NORTHEAST DISTRICT DEPARTMENT OF HEALTH

B100/APPLICATION

**SUBJECT: FILE #23000016 -- BUNGAY HILL ROAD #186, MAP #7272, BLOCK #34, LOT #0F25,
WOODSTOCK, CT**

B100a / Change in Use Application

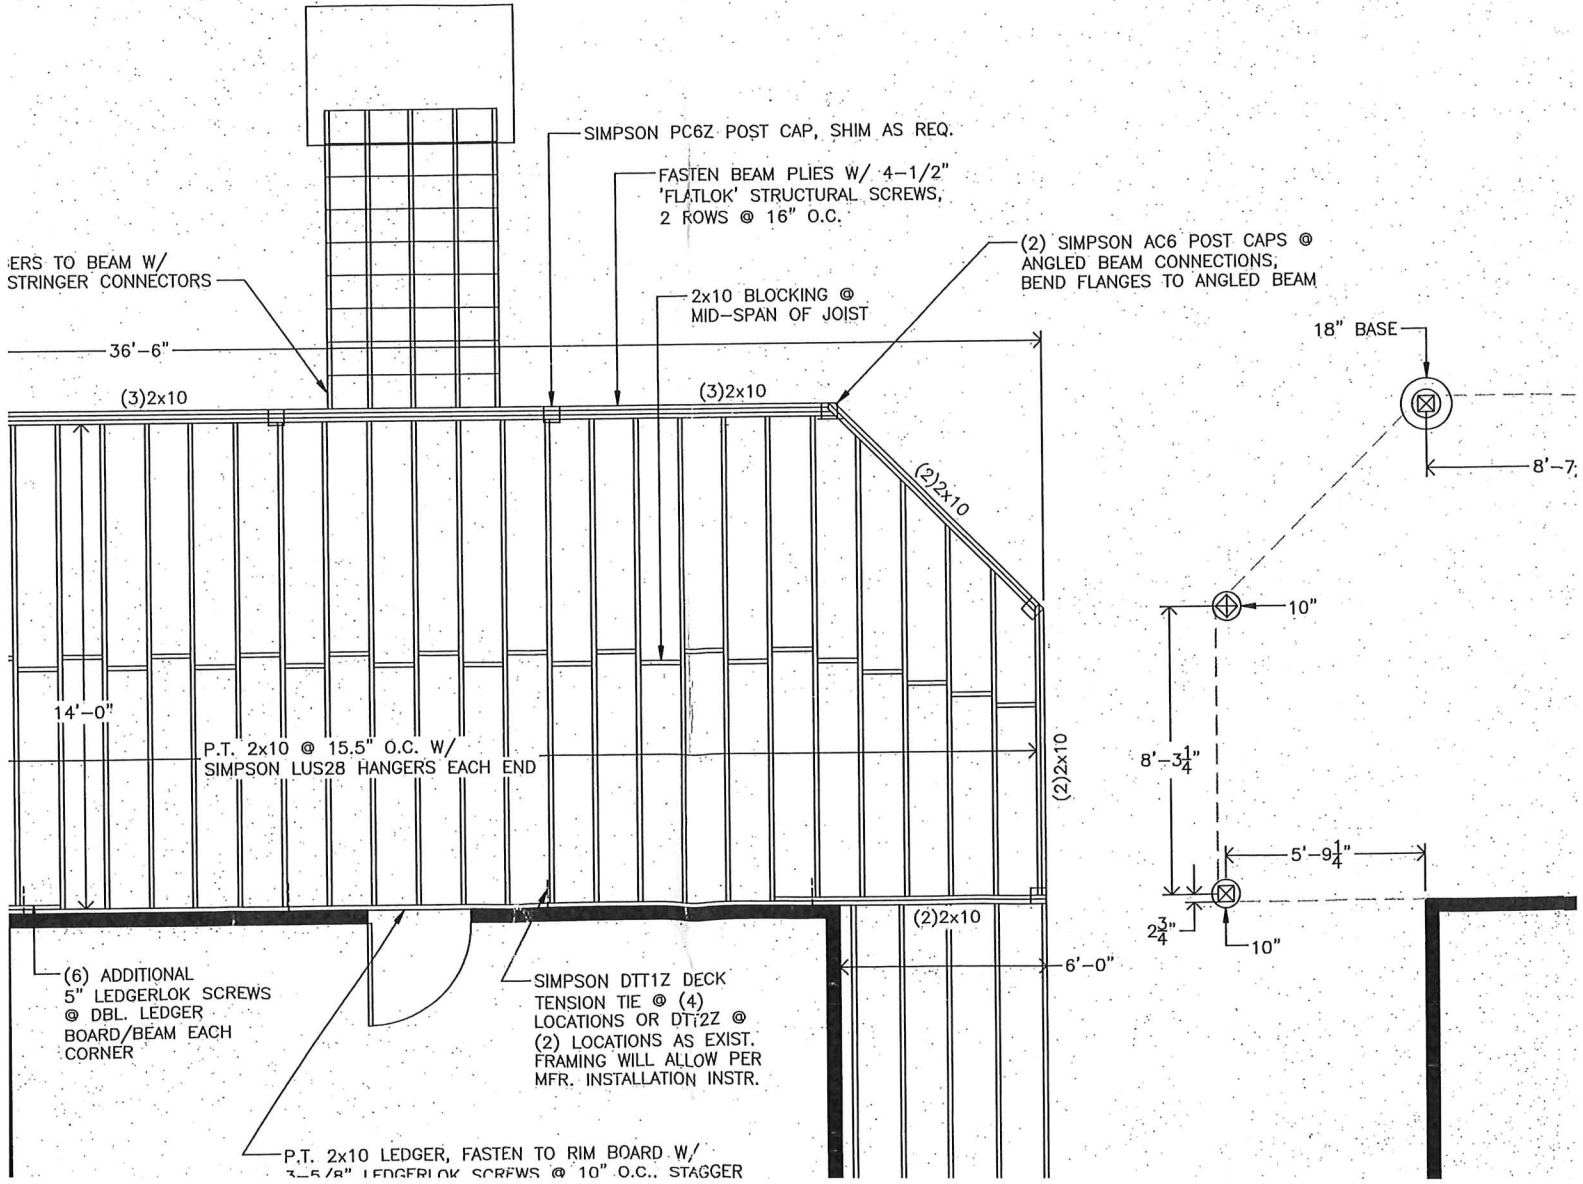
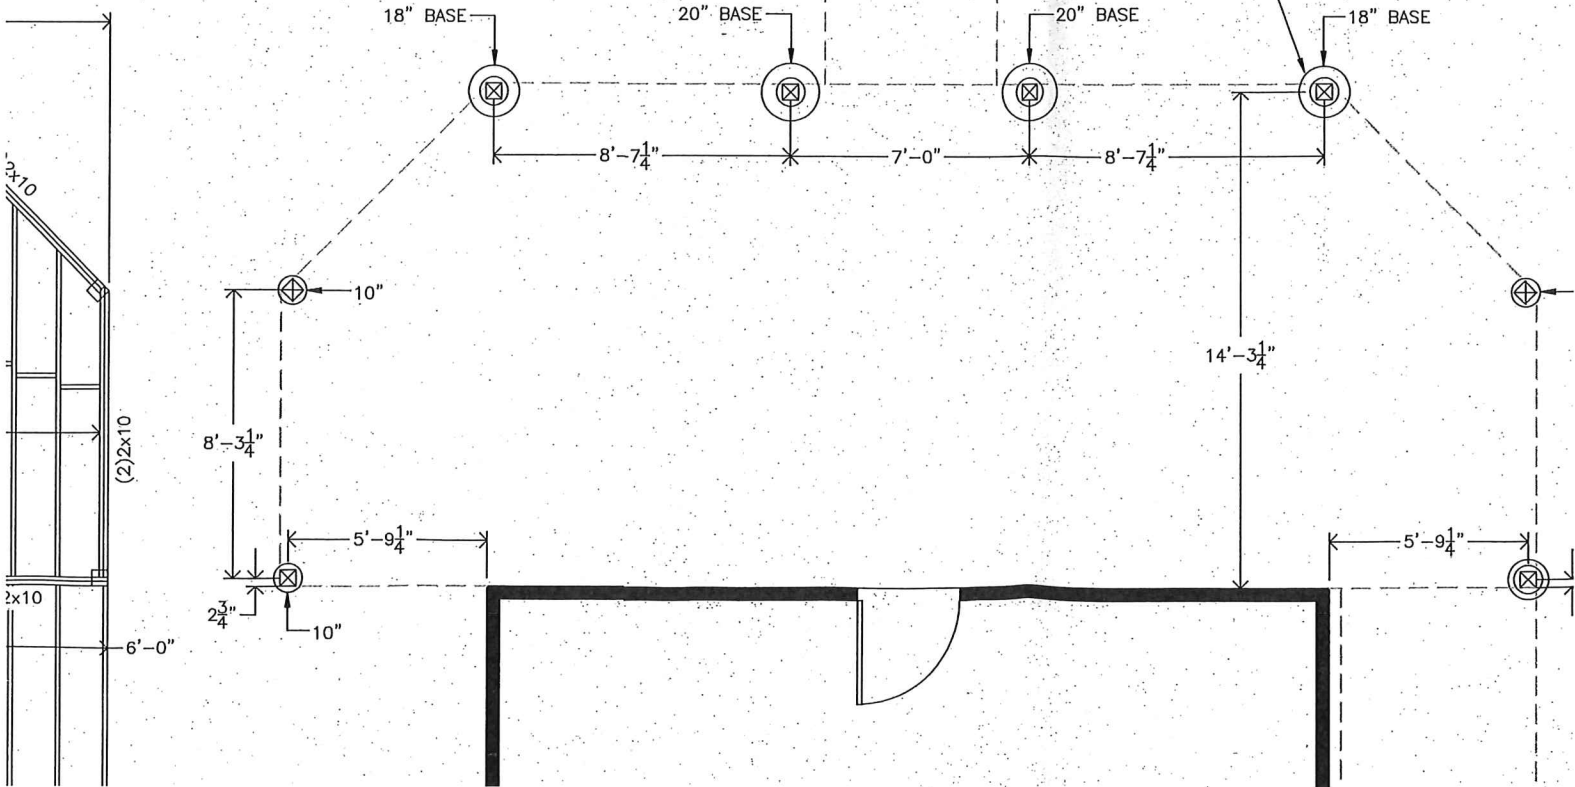
1. Maintain a minimum of 10 feet from the existing septic tank and leach field with the proposed deck.
2. Septic system to be taped off during construction to ensure proper separating distance is maintained and to protect from heavy traffic or storage of building materials in this area.
